Product hierarchy no. *				Part no.	SBU	Type / Description	Customer part no.
SBU	PG	PUG	Type				
02	007	013	0000002297	See list below	Connectors	4797 Appliance Outlet 16A 70°

## 2 Type of change

Product Change Notification					PCN - 4797 Cord Retention Notches Added - Part		
owner	creation date	release date	released by	change order no	rev	page	
vetersa	04.03.2020	13.05.2020	muehlema	2019486	A	1 of 1	D10-043-493

Old product appearance	New product appearance

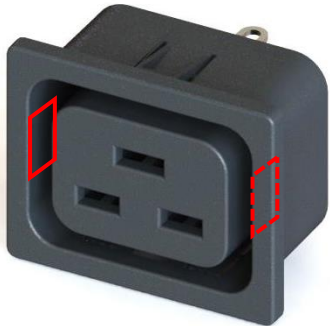
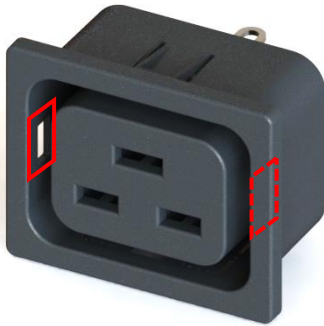
Two laterally positioned notches added to the molding body.

The notches are implemented as a standard feature to be compatible with side latching cord retention systems such as P-Lock, SecureLock or TwyLock.

Form	Yes	Laterally positioned notches. Fully backwards compatible
Fit	No	-
Function	Yes	Compatibility with side latching cord retention systems
Manufacturing	No	-
Label	No	-
Packaging	No	-
